BID ADDENDUM NO.1

2181539 Bank on Buffalo, Niagara Falls, NY

There was an error during the printing process that caused the structural & HVAC items to not appear in the Architectural drawings. Some of the drawings being replaced are only to show the missing items for clarification. No actual changes are occurring on these sheets. Any changes to the drawings are clouded & tagged.

2 WALL/MULLION DETAIL
A503 SCALE: 1 1/2" = 1'-0"

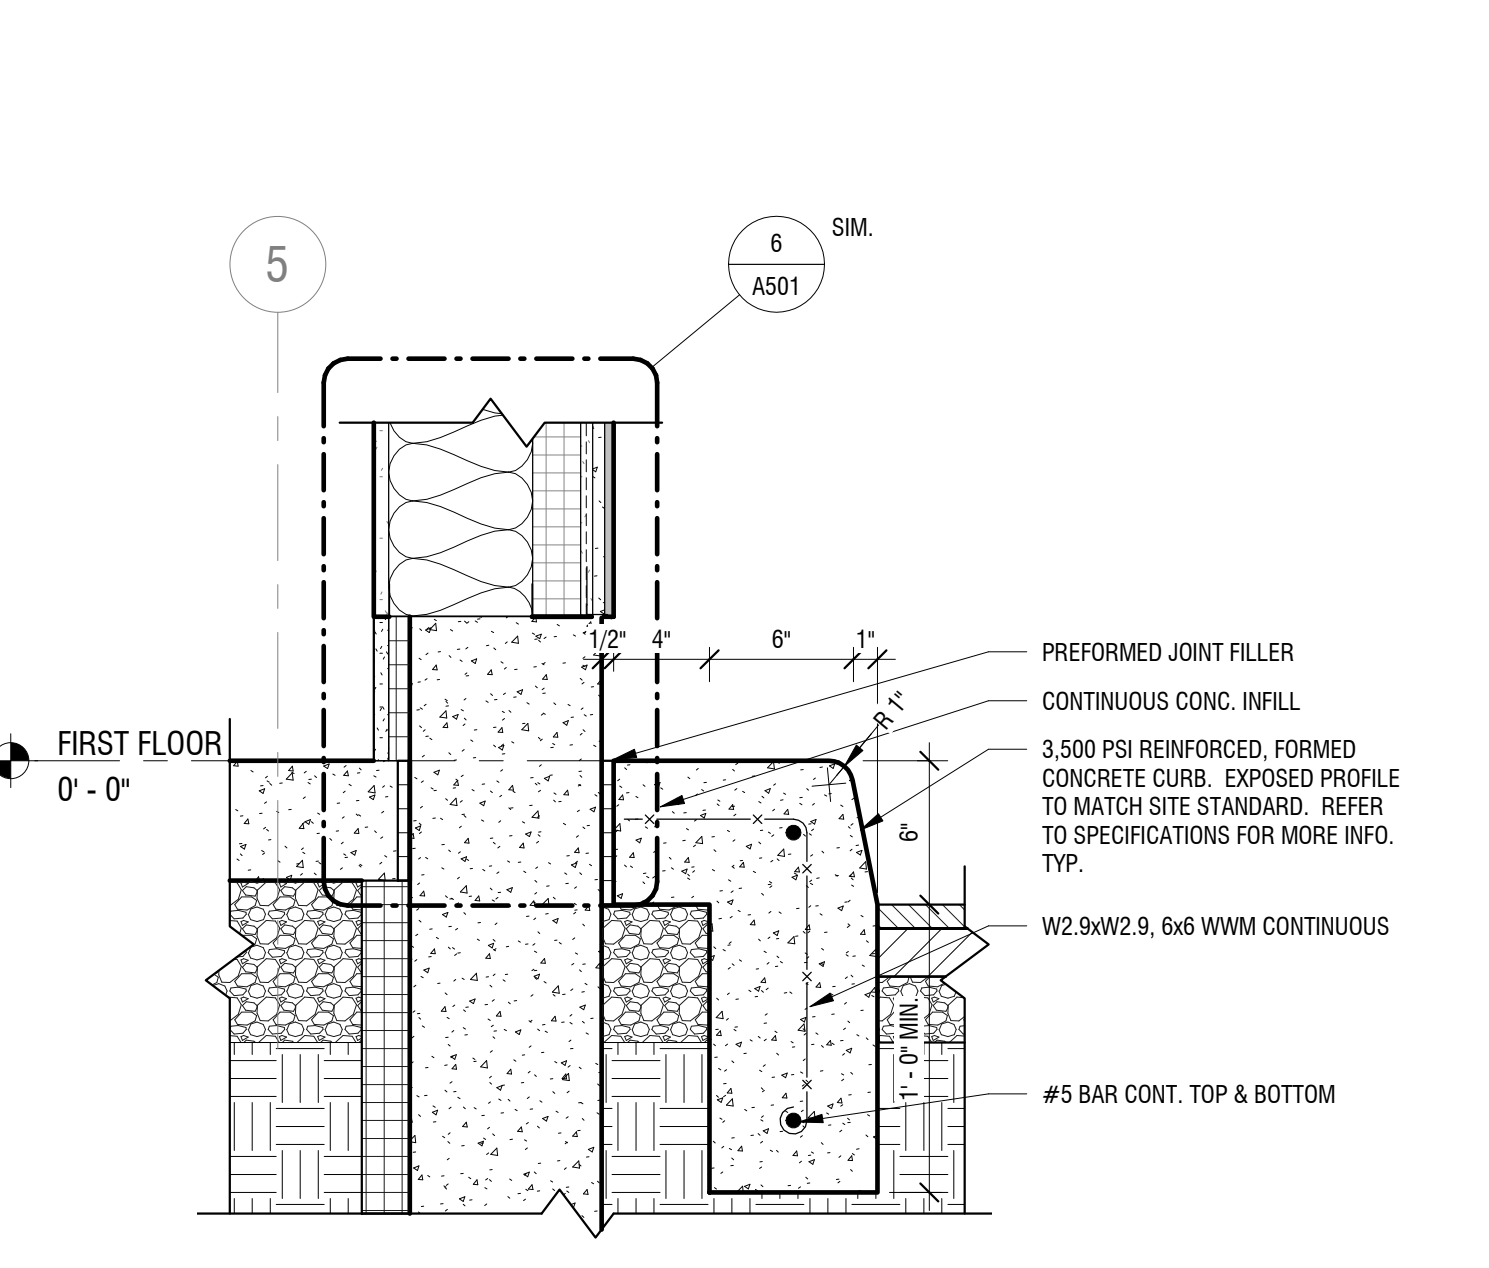
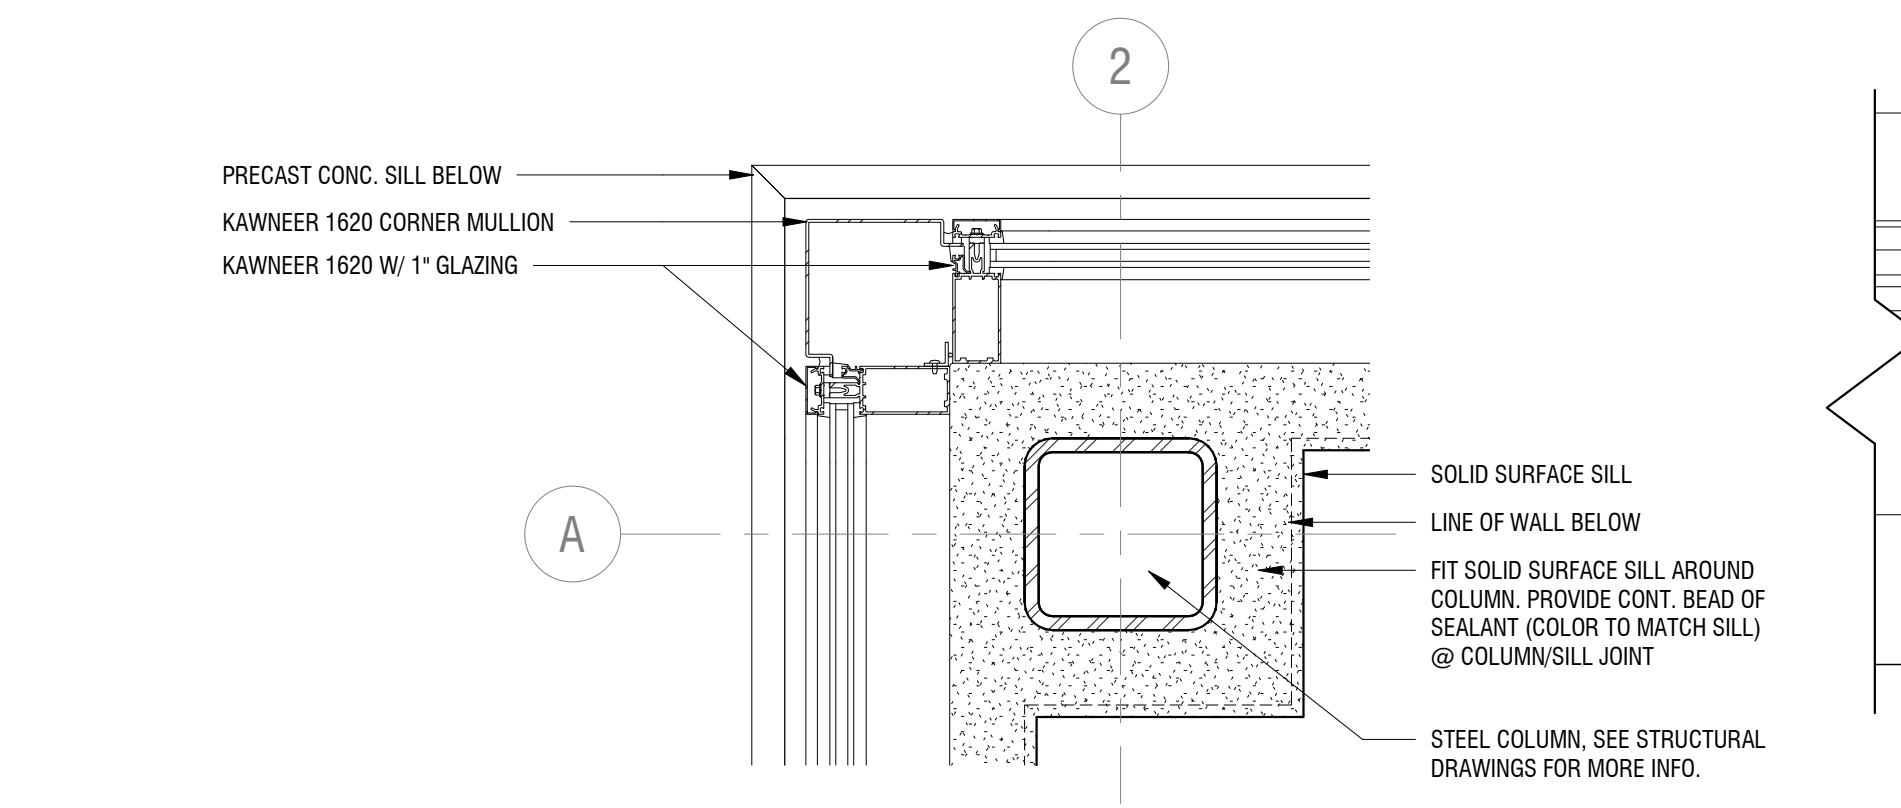
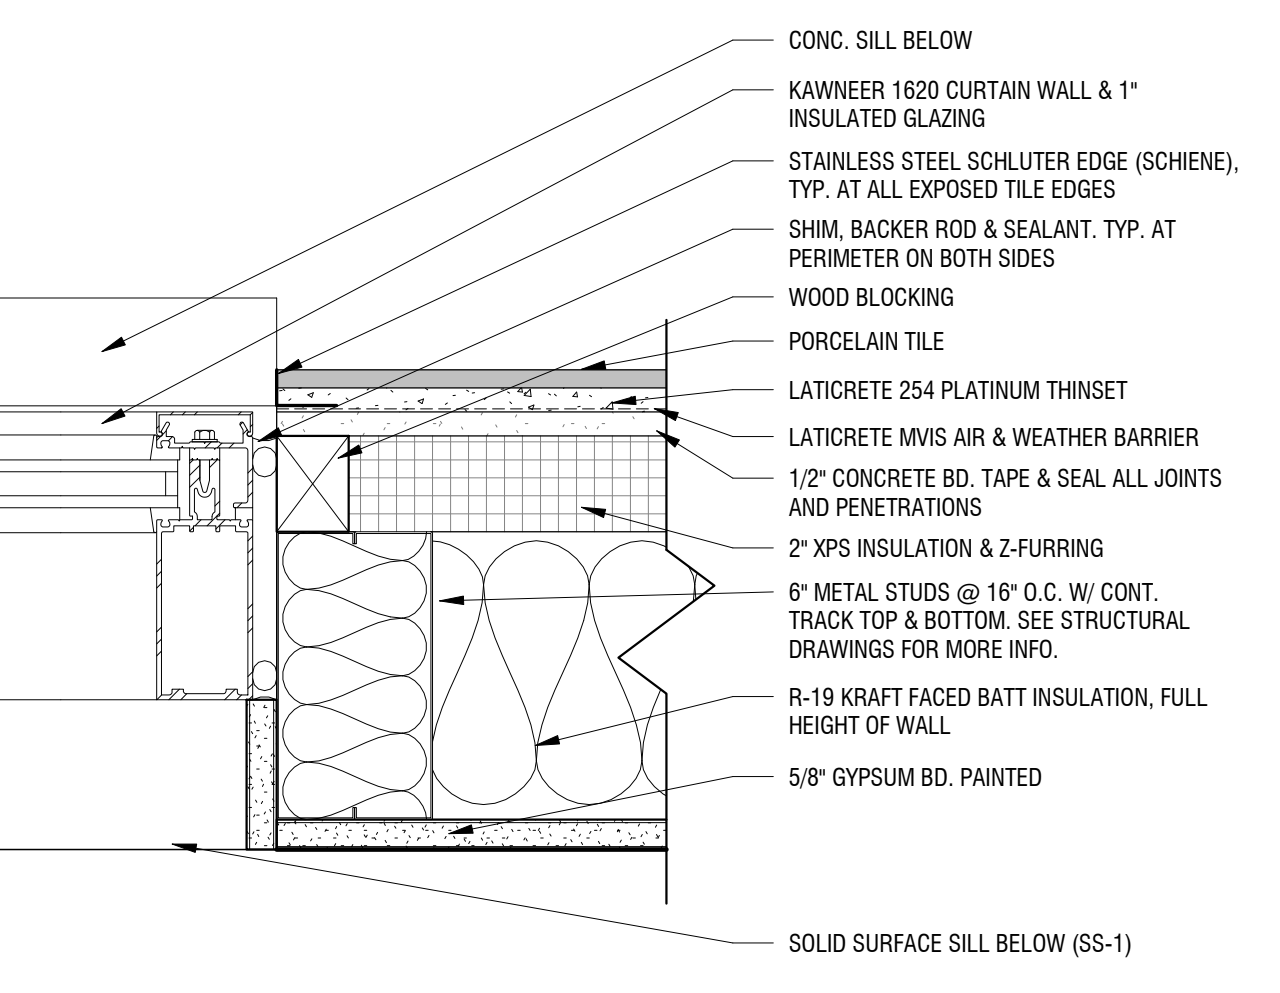
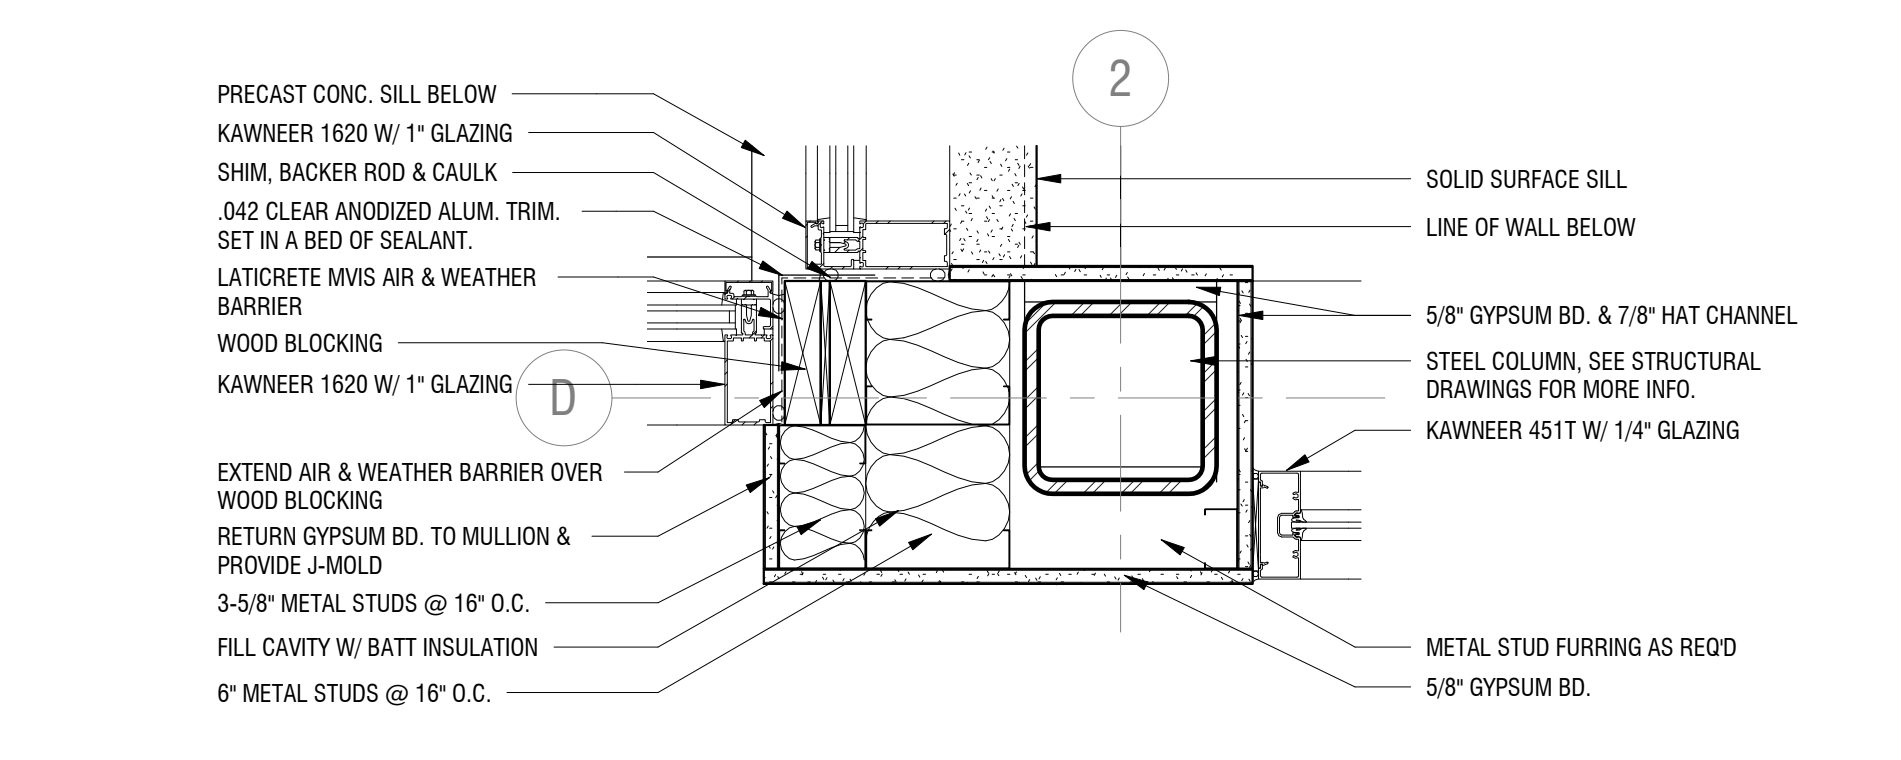
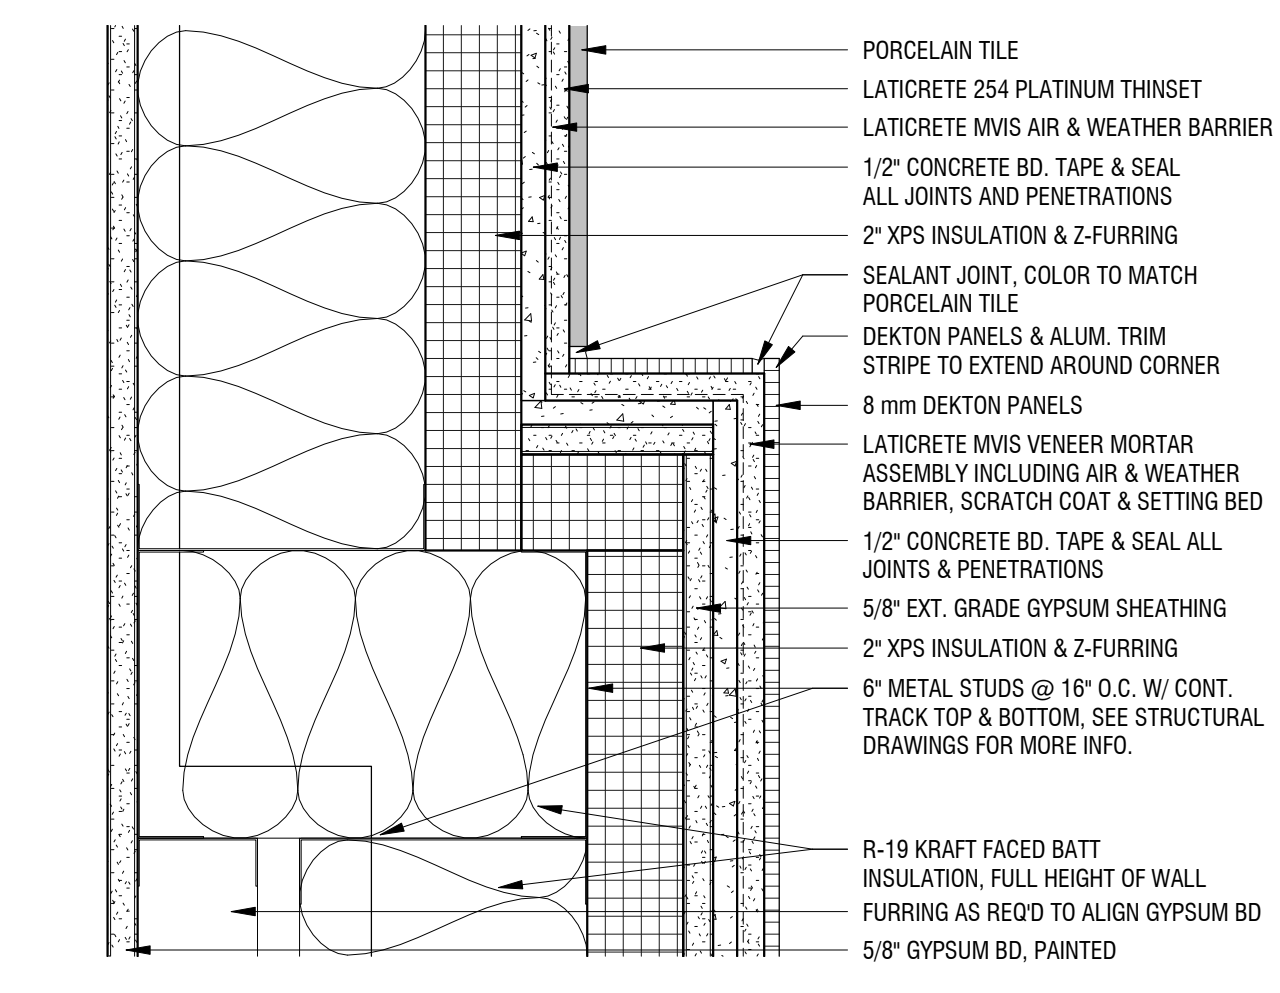
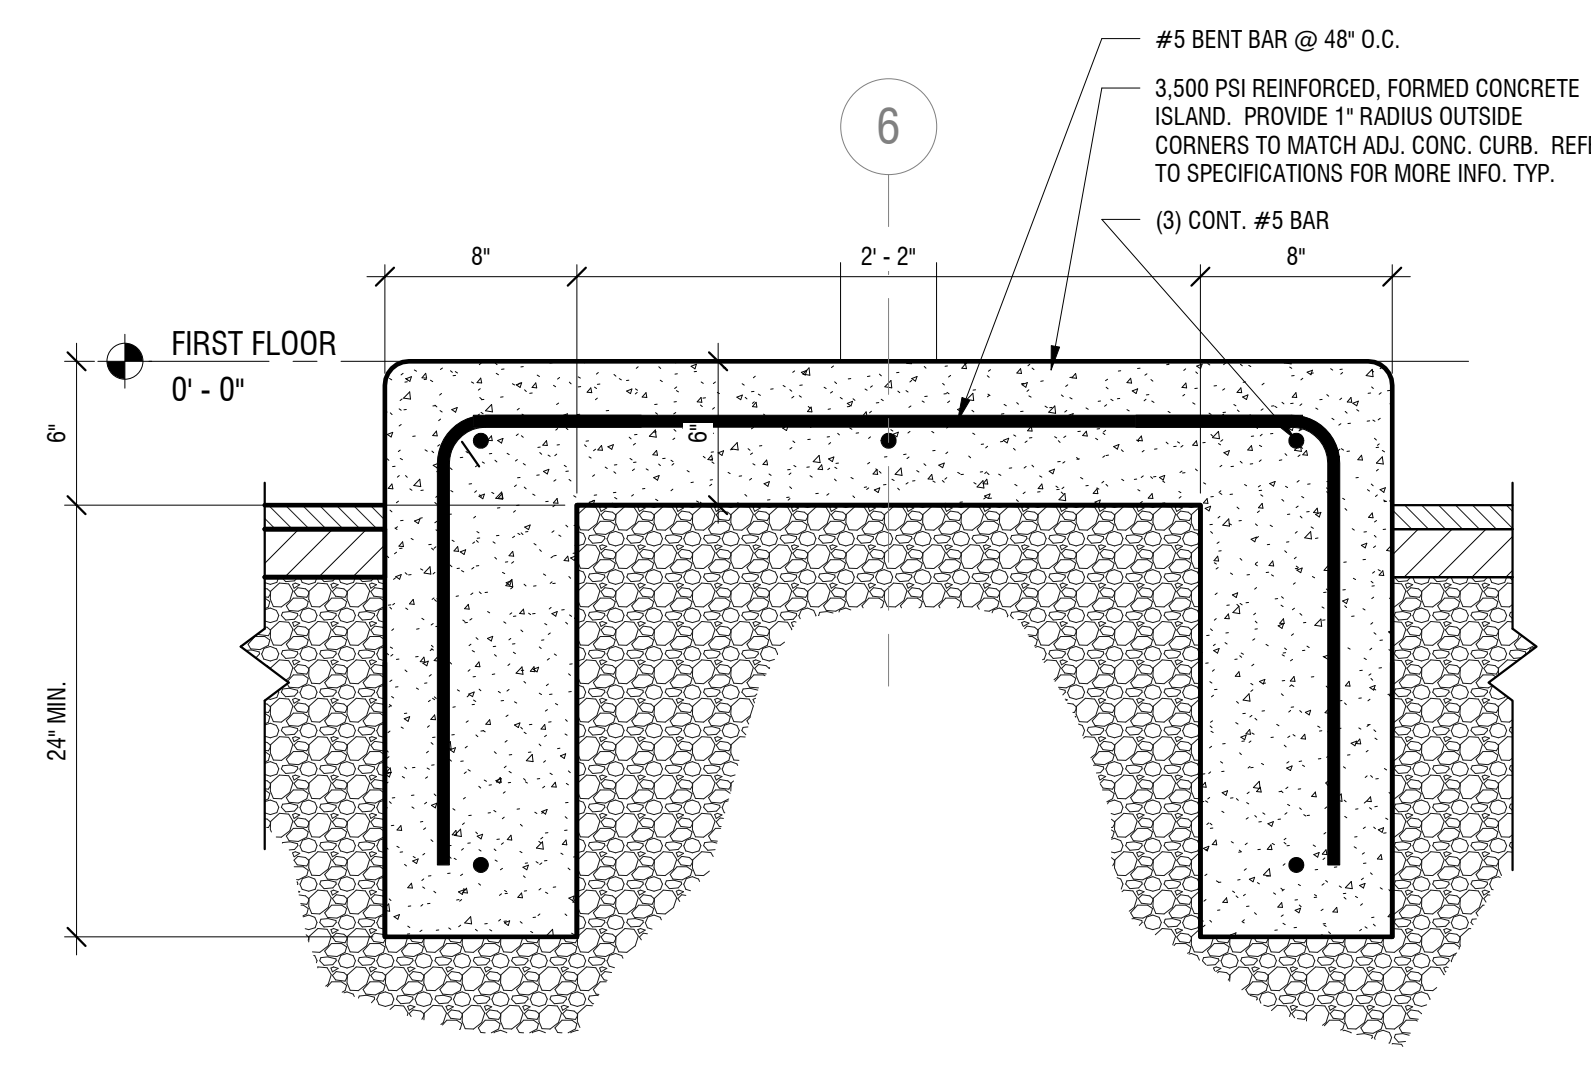
- O. Drawing A503**
 - 1. DELETE Drawing in its entirety
 - 2. ADD replacement Drawing A503
 - 3. Added Customer feature section & deleted vertical cove light detail. Vertical cove lighting is to be removed from the project. It is **not** otherwise noted on the Electrical drawings.
 - 4. Structural items are now shown on drawings.
